## **Authors' response to Referee 1 (RC1)**

## Authors' response to Referee 2 (RC2)

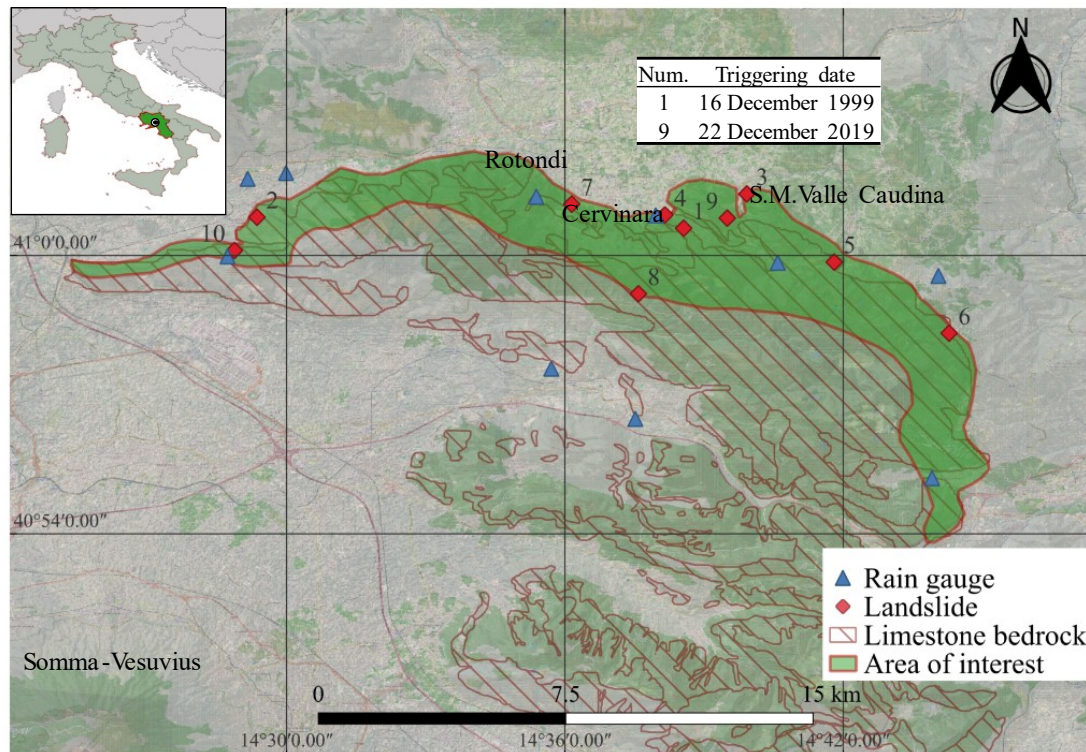
*The definition of “large area” is somehow unclear. 80km<sup>2</sup> for the case-study test zone is not a very large zone when compared to many landslide data-driven susceptibility assessments. There is maybe some way to better define/constrained this scale of analysis context.*

Thank you for raising this interesting issue. The distinction between large and small areas is indeed subjective and is often tied to the techniques used to understand the process under study. Data-driven susceptibility models are indeed often applied to areas larger than our study area. However, they usually rely on techniques designed to handle large datasets and extract relationships among the data without considering the physics of the involved slope processes. In our case, instead, we make use of a physically based model of the slope response to precipitation, and this can be done only if it is applied to a homogeneous geomorphological context. This is usually done with detailed flow and equilibrium models at slope scale, but here we encompass hundreds of slopes in an area of nearly 100 km<sup>2</sup>. On the other side, the statistical-empirical approaches to define landslide thresholds are usually designed for larger areas, at regional or even national scale (Guzzetti et al., 2007; Peruccacci et al., 2017). However, these approaches merely rely on the correlation between rainfall and landslide occurrence, without introducing information about the physical behavior of the studied slopes.

Differently, our approach is based on a physically grounded rationale, aiming to identify causal (physical) relationships rather than mere correlations (although complex and non-linear as those that can be identified with data-driven approaches). As the Referee correctly points out, we used infiltration and slope stability models to replicate the hydrological conditions that lead to landslides in a specific region. Usually, this approach is suited to representing a specific slope at a small local scale. In our study, we started from a reference slope inclined at 40°, with a 2 m thick soil cover overlying the limestone bedrock. This geometry resembles the features of the slope involved in one of the most catastrophic landslide events in the study area: the Cervinara landslide in 1999. This event is shown with nr. 1 in Figure R2-1, where all the landslides reported in the existing catalogues are also represented. Then, we extended the analysis to a larger area, approximately 80 km<sup>2</sup>, as indicated by the green-hatched region in Figure R2-1. To do this, we accounted for the effects of the variability of slope and soil properties, as well as of the effects of the variability of weather forcing.

This is the meaning of “large area” in our case: extending the results of a single slope to an area including hundreds of slopes with variable characteristics, although within the same geomorphological context. We will better clarify this aspect in the revised manuscript.

## Standard normal distribution

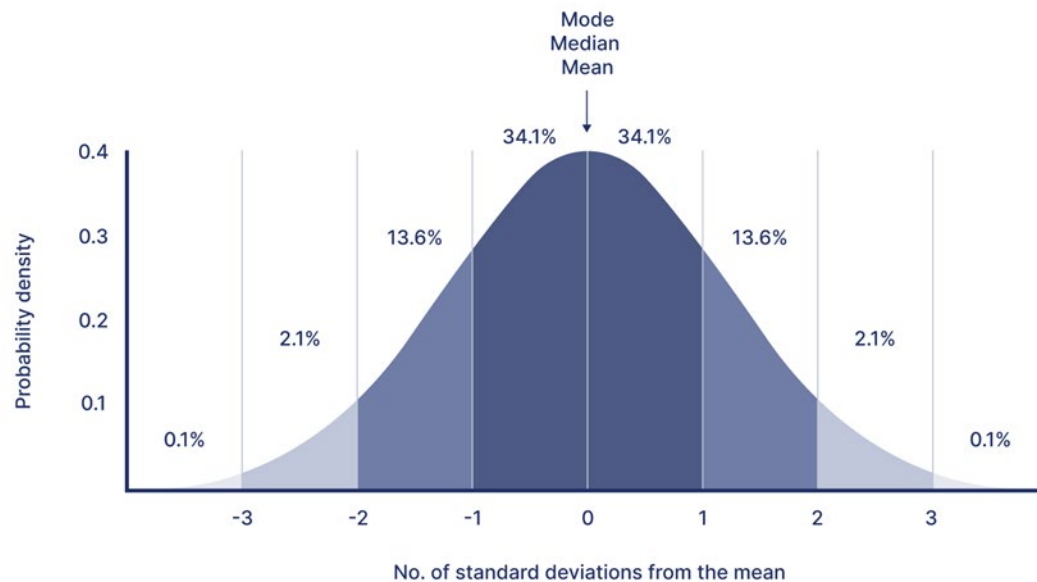
*Figure 4 (and in other places). Is the use of decimal values in the percentage valid? Does it make sense?*

The envelopes depicted with red solid and dashed lines in Figure 4 represent the bounds containing 68.3% and 86.6% of the data, respectively. These are the percentages of the data that,

in a Normal distribution, belong to intervals centered around the mean with width of two and three standard deviations, respectively. As can be seen in many figures and tables found in literature (see an example below), it is perfectly legitimate to express percentages with decimal digits (if we misunderstood the comment, please accept our apologies).
